| <b>SUBJECT:</b>    | Sketch Plan Review of a Proposed Townhome Development in Erie Commons Filing No. 4.           |
| <b>PURPOSE:</b>    | Review of a Sketch Plan for 92 townhome units at the east end of Erie Highlands Filing No. 4. |
| <b>DEPARTMENT:</b> | Community Development Department                                                              |

## Proposed Sketch Plan

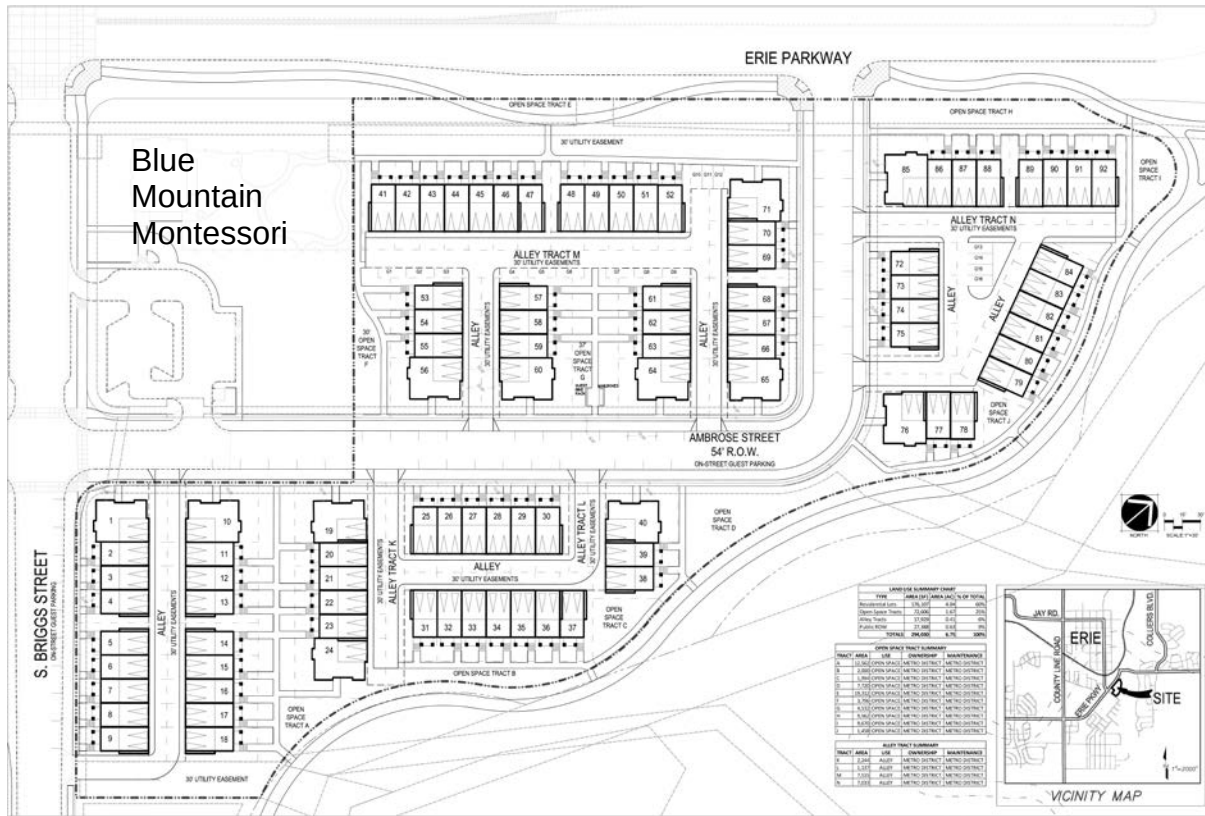
1. Lack of a pocket park.
  - a. The closest park within Erie Commons is beyond our  $\frac{1}{4}$  mile walking distance to a park. Staff recommends that the applicant provide a pocket park.

- a. Staff is concerned with the volume of traffic on Erie Parkway being a problem for the future townhome owners of units oriented with front outdoor porches facing the street. Staff recommends that the majority of units be side loaded to Erie Parkway.

3. Concern over the townhomes adjacent to the Coal Creek spine trail.
  - a. Multifamily development front doors should be oriented to a street or common courtyard that is a minimum of 30 feet wide with walkways that connect to adjacent streets. The applicant submittal faces several units directly onto the Coal Creek spine trail. The Coal Creek spine trail is a regional trail; which is our highest volume trail corridor with the highest speeds. Staff recommends that access onto the spine trail should be limited to distinct access points and setbacks should be adhered to so that conflicts between homeowners and trail users can be minimized. Staff is recommending that the majority of units be side-loaded to the spine trail similar to what is proposed in the Sketch Plan on the south end of the development. This allows for views into the

- open space while funneling all users to the spine trail on one common walk system.
- b. OSTAB was also concerned over the orientation and location of the townhomes to the spine trail. Please see their attached review comments.
- 4. Orientation of alley and garages to the Coal Creek spine trail.
  - a. The alley in Tract N extends very close to the spine trail which does not leave much room for landscape screening of the backside and row of garages for dwelling units 89-92. Additionally, staff is concerned about winter snow plowing that would be needed in the alley pushing snow onto the sidewalk system.

Town staff has generally reviewed the proposed Sketch Plan for compliance with the Erie Commons PD requirements and has provided the applicant with detailed comments in the attached staff review memos. Currently, the proposed development does not meet the minimum lot size of 2,000 square feet and the lot setback requirements on all lots. The applicant will need to amend the Erie Commons PD to accommodate the proposed development. The Erie Commons PD Zoning Map and Development Guide are attached for your reference.
